LONG CHIH INDUSTRIAL COMPANY LIMITED

SAFETY RECALL NOTICE

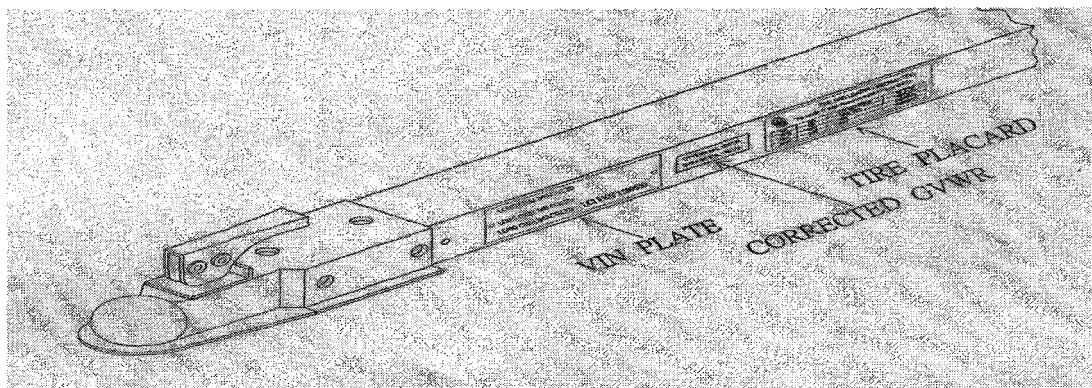
Long Chih – trailer manufacturer has decided that all our trailers manufactured from September 1, 2005 to December 31, 2008 fail to conform to Federal Motor Vehicle Safety Standard No. 110. “Tire Selection and Rims.” These trailers are missing the tire placard label which states the tire size, tire pressure, and maximum load information. The gross vehicle weight rate (GVWR) on the VIN plate on some of the trailers is incorrect and the GVWR and gross axle weight rate (GAWR) units should be specified in pounds on the VIN plate. Also, the owner’s manual is missing the information to report suspected safety defects as required by Federal Regulation Title 49 CFR Part 575 “Consumer Information.” A misprinted label could lead to improper vehicle loading specification or tire inflation which could result in a tire failure, increasing the risk of a crash.

Enclosed with this letter is the correct tire placard label and GVWR label. Please affix these labels to the driver’s side of the trailer tow bar near the VIN plate as shown below in this picture. Also enclosed is the “Reporting Safety Defects” statement as a part of owner’s manual. Please read this statement and save it with

1. Clean the surface of the tow bar driver's side as on above diagram.
2. Please affix the provided corrected GVWR label first then tire placard on clean surface of tow bar.
